Illinois Environmental Protection Agency

MEMORANDUM

DATE: May 31, 1979
TO: Division File
FROM: John Taylor
SUBJECT: Macon County - LPC 11580408 - Decatur/Macon County #2

Subject Macon County - LPC 115B0408

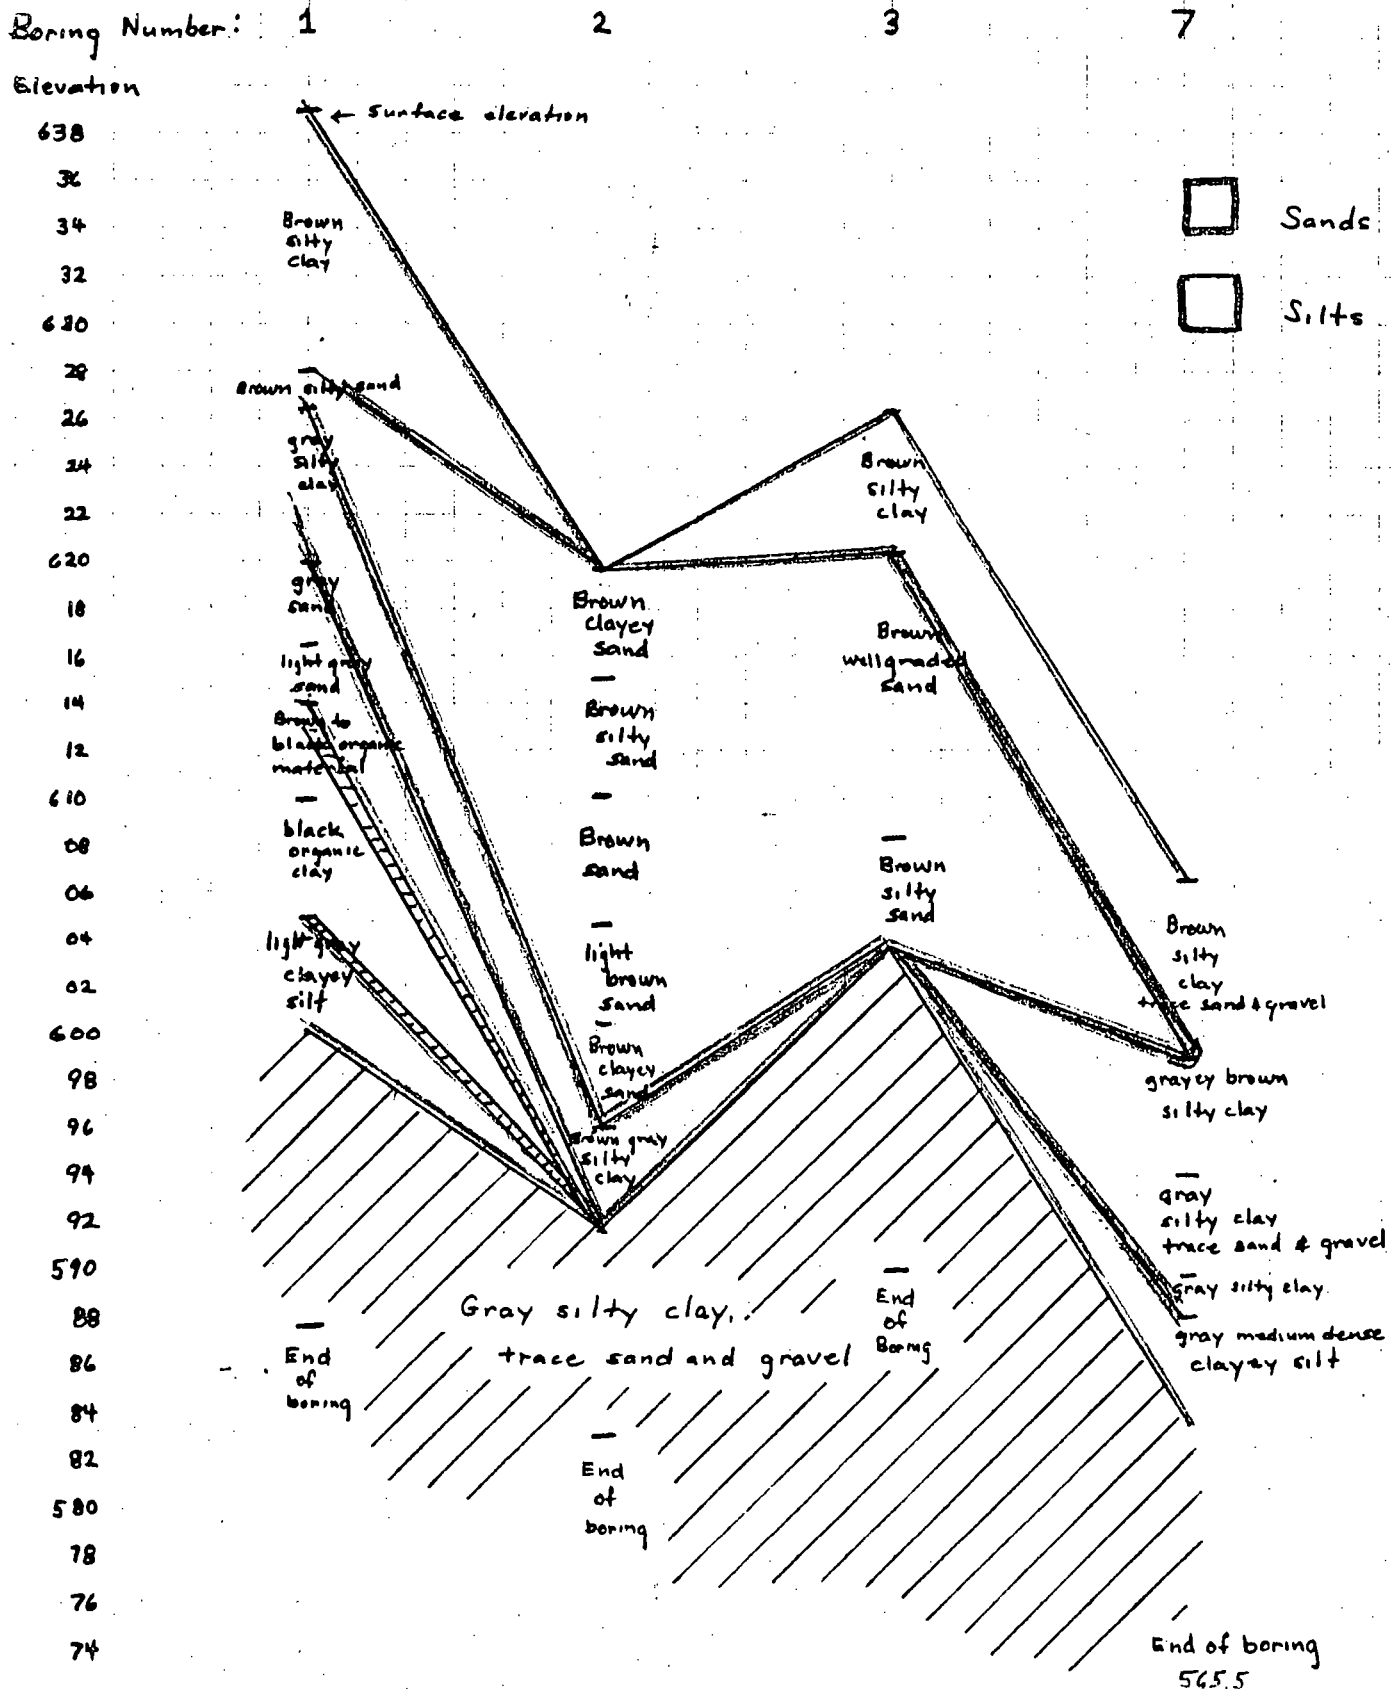
The "Hydrologic and Geologic Report", submitted as part of the original permit application, casts doubt on this site's suitability for disposal of special wastes. The attached chart, adopted from soil profiles in this report, show that there is a great deal of sand and silt present that will necessarily have to be used for daily and intermediate cover. Once site development reaches the point at which the drainage culvert under the dike is properly plugged and sealed this might not be a major concern. At that time all contaminants would be contained within the seal and the dike. However, until that point is reached, any liquid build up in the filled areas may easily flow through the porous cover materials, drain into the surface water drainage channels, and leave the site through the culvert. This situation appears to have existed for several years. According to the permit, the seal along the north and west sides of the site will not be constructed and the culvert, if it still existed, would not have been plugged until late in the life of this site.
